APPLICATION NO.	FILING DATE	FIRST NAMED INVENTOR	ATTORNEY DOCKET NO.	CONFIRMATION NO.
09/898,806	07/03/2001	Koki Kanda	0941.65658	5709

Office Action Summary

DETAILED ACTION

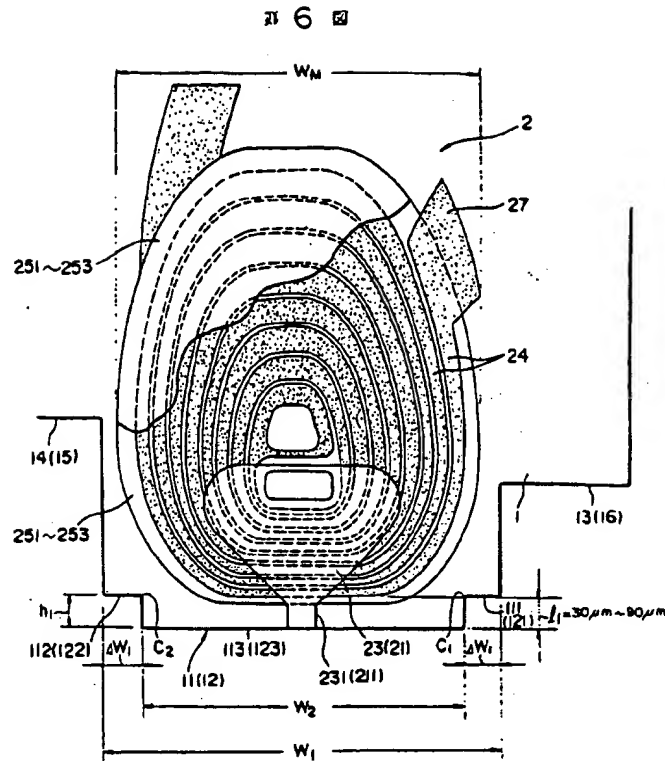
protective layer 3 is recessed away from corner intersection of the distal end of protective layer 3 and the ABS forming a ROUNDED recessed corner.

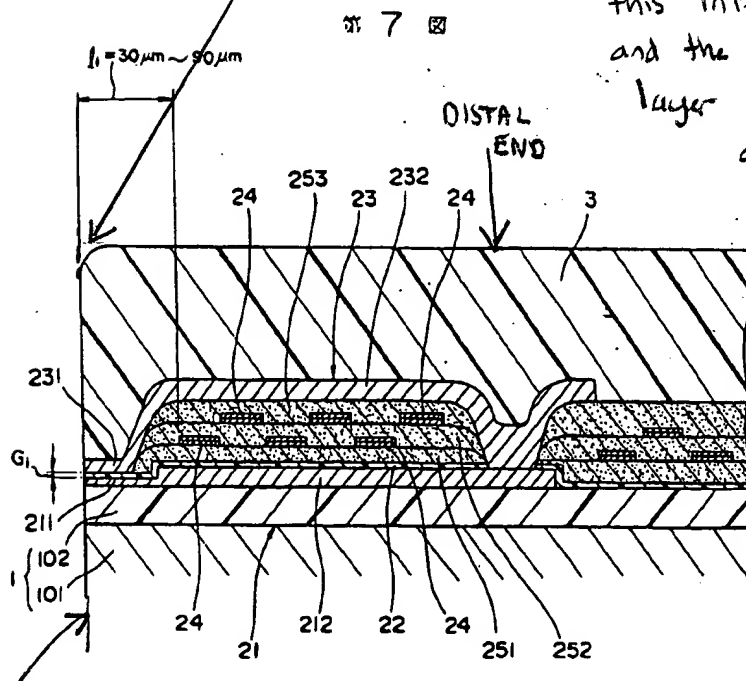
missing corner, hence curved surface at this intersection of layer 3 and the ABS. That is layer 3 is recessed away from a square corner.
